PLANNING AND ZONING COMMISSION MEETING Tuesday, June 21, 2016 • 7:00 p.m. West Branch City Council Chambers, 110 N. Poplar St.

GRADING CONCEPT AND EROSION CONTROL PLAN LYNCH HEIGHTS

PRELIMINARY PLAT LYNCH HEIGHTS WEST BRANCH, IOWA

Re: Preliminary Plat for Lynch Heights, West Branch, Iowa

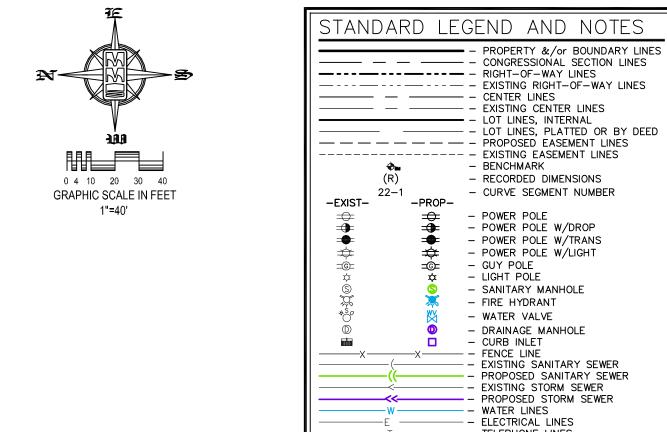
Protective covenants are being prepared and will be available for recording with the final plat.
- 18. Identification of areas prone to erosion and, by separate document attached to the preliminary plat, a grading plan to explain the methods that will be used to control erosion pursuant to the requirements of this chapter. (See Section 170.15(15)

A grading and erosion control plan accompanies the preliminary plat and was attached.

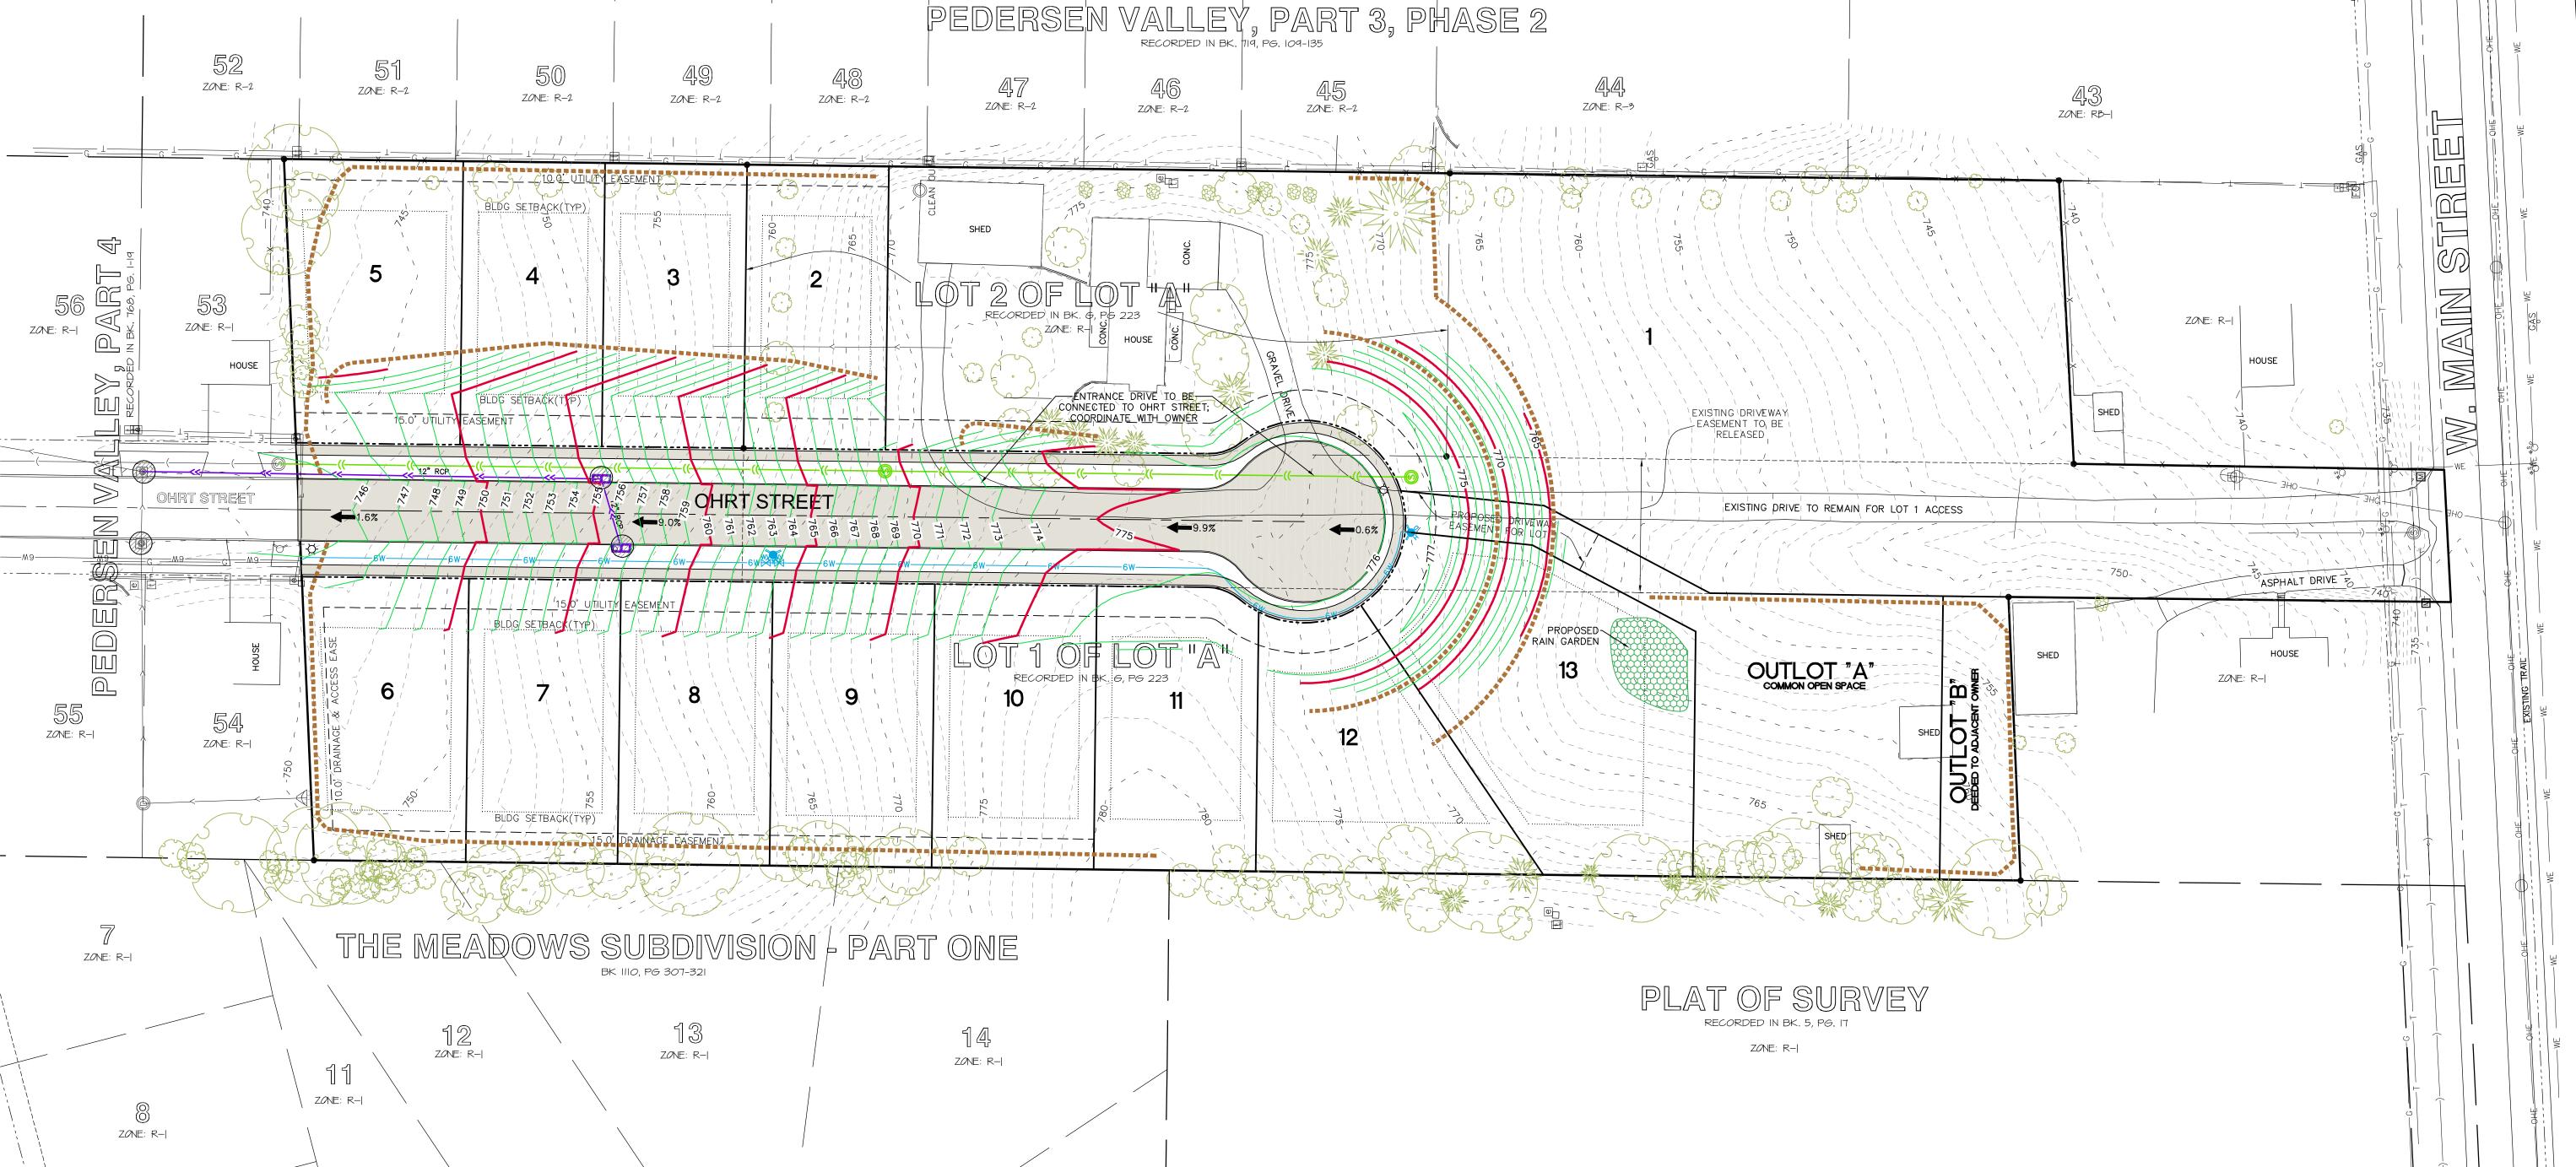
- 6. Proposed layout of lots, showing numbers, approximate dimensions and the square foot areas of lots that are not rectangular.

The existing driveway easement has been eliminated on Lot 1. A new easement has been added on the northerly end of Outlot "A" to allow Lot 1 to connect from the culdesac to the existing drive.
- 14. A general summary description of any protective covenants or private restrictions to be incorporated in the final plat.

The double labels on Lots 6-12 have been corrected and the lots have been adjusted to fit the land according.
- 9. Present and proposed easements, showing locations, widths, purposes and limitations..
